**RE: Application for Proposed Waiver of Waste Discharge Requirements for  
Alternative Onsite Wastewater Disposal Systems - 192 & 194 San Remo Road,  
Carmel Highlands**

**Exhibit A**  
**Applicant's Responses to Project Opponent's Comments**

**SUBJECT: Results of Additional Soil Testing  
and Discussion of Potential Influence of Rainfall.**

## Exhibit E

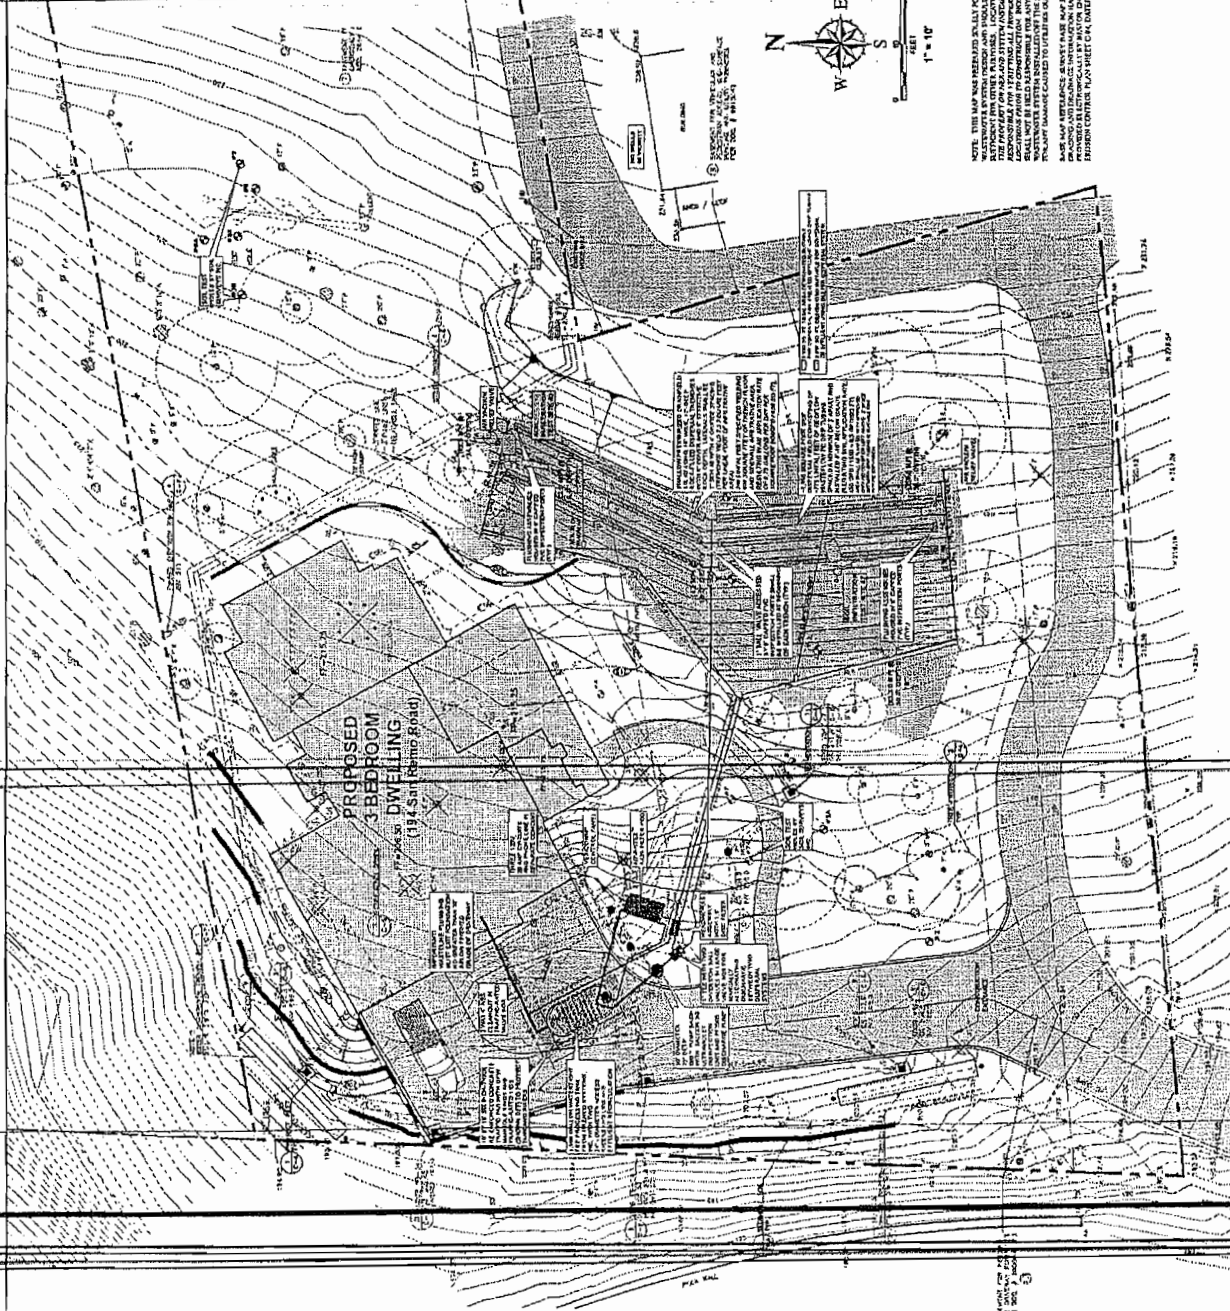
15	<p>Monterey Bay Engineers, Inc.; client – Dr. &amp; Mrs. Hoxie</p>	<p>The plans for parcel -005 show a portion of a private road easement along the southerly boundary as San Remo Road. This property does not have frontage on San Remo Road as the plans would imply.</p>	<p>The commenter is correct. The revised plan is included as <b>Exhibit "E"</b>.</p>
16	<p>Monterey Bay Engineers, Inc.; client – Dr. &amp; Mrs. Hoxie</p>	<p>There is a significant conflict between the leach</p>	<p>The commenter is correct. The consultant used the wrong base map for driveway configuration. The corrected, revised plan is included as <b>Exhibit</b></p>
